Access Compliance Report

Public Rights-of-Way

(Pedestrian Signals)

Intersection ID: N/A	Main Street:	Cross Street: N/A	Location: N/A
ADA ID: CE6E6FF6E392	Signal Type: One Push Button-Non APS	Overall Compliance: No	Severity Score: BTN 1: N/A BTN 2: N/A No BTN: N/A
Codes/Mitigation Info/Possible Solution		Field Measurements/Component Compliance

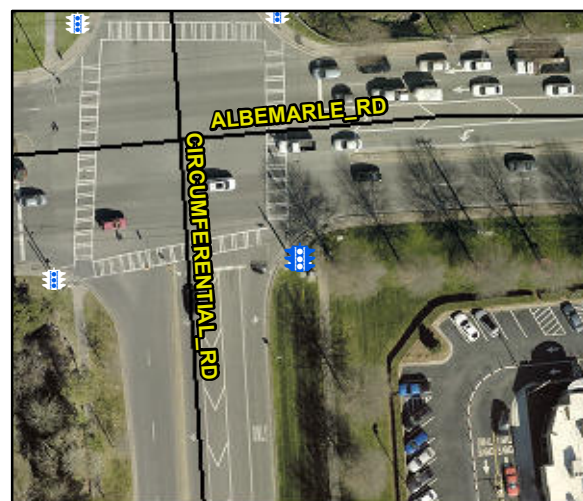
Compliance	Description	Data	Compliance	Description	Data
	Button Count	Button1	N/A	Distant to Additional Button (in)	N/A
	Additional Button Present?	No		Additional Button ID	N/A
N/A	Signal Buttons Required?	N/A	N/A	Additional Ped Posts Required	N/A
	How Many Ped Street Xings?	2		Located In An Island/Median?	No
N/A	B 1 Sign Present?	Yes	N/A	B 2 Sign Present?	N/A
Yes	B 1 Sign Purpose?	Yes	N/A	B 2 Sign Purpose?	N/A
No	B 1 Sign Lettering & Contrast?	No	N/A	B 2 Sign Lettering & Contrast?	N/A
Yes	B 1 Parallel To XWalk?	Yes	N/A	B 2 Parallel To XWalk?	N/A
Yes	B 1 PAR to Button?	Yes	N/A	B 2 PAR to Button?	N/A
Yes	B 1 PAR to XWalk?	Yes	N/A	B 2 PAR to XWalk?	N/A
Yes	B 1 Clear Floor Space?	Yes	N/A	B 2 Clear Floor Space?	N/A
N/A	B 1 FWD Approach?	Yes	N/A	B 2 FWD Approach?	N/A
N/A	B 1 FWD Approach Constrained?	No	N/A	B 2 FWD Approach Constrained?	N/A
No	B 1 FWD Approach Reach (in)	12.0	N/A	B 2 FWD Approach Reach (in)	N/A

N/A	B 1 FWD Approach Width (in)	N/A	N/A	B 2 FWD Approach Width (in)	N/A
N/A	B 1 FWD Approach Obstruction?	Yes	N/A	B 2 FWD Approach Obstruction?	N/A
N/A	B 1 FWD Approach Obstruction Dist (in)	4.5	N/A	B 2 FWD Approach ObstructionDist (in)	N/A
N/A	B 1 PARA Approach?	Yes	N/A	B 2 PARA Approach?	N/A
N/A	B 1 PARA Approach Constrained?	No	N/A	B 2 PARA Approach Constrained?	N/A
Yes	B 1 PARA Approach Reach (in)	9.0	N/A	B 2 PARA Approach Reach (in)	N/A
N/A	B 1 PARA Approach Width (in)	N/A	N/A	B 2 PARA Approach Width (in)	N/A
N/A	B 1 PARA Approach Obstruction?	Yes	N/A	B 2 PARA Approach Obstruction?	N/A
N/A	B 1 PARA Approach Obstruction Dist (in)	3.0	N/A	B 2 PARA Approach ObstructionDist (in)	N/A
No	B 1 Clear Floor Space Slope (%)	6.1	N/A	B 2 Clear Floor Space Slope (%)	N/A
No	B 1 Clear Floor Space XSlope (%)	3.5	N/A	B 2 Clear Floor Space XSlope (%)	N/A
N/A	B 1 PAR Slope (%)	3.4	N/A	B 2 PAR Slope (%)	N/A
Yes	B 1 Height (in)	39.0	N/A	B 2 Height (in)	N/A

Yes	B 1 Clear Xing Direction?	ClearlyMarked	N/A	B 2 Clear Xing Direction?	N/A
	B 1 Crossing Direction	To N		B 2 Crossing Direction	N/A
Yes	B 1 DistanceTo XWalk (in)	51.0	N/A	B 2 DistanceTo XWalk (in)	N/A
No	B 1 DistanceTo Curb (in)	78.0	N/A	B 2 DistanceTo Curb (in)	N/A
Yes	B 1 Diameter (in)	2.0	N/A	B 2 Diameter (in)	N/A

Possible Solutions: Replace Signal Push Button With APS Button on New Post. Remove & Replace Sign.

PROW/ADA: R410.6, TMUTCD 4e.08, R404.2, R404.3, R406.2
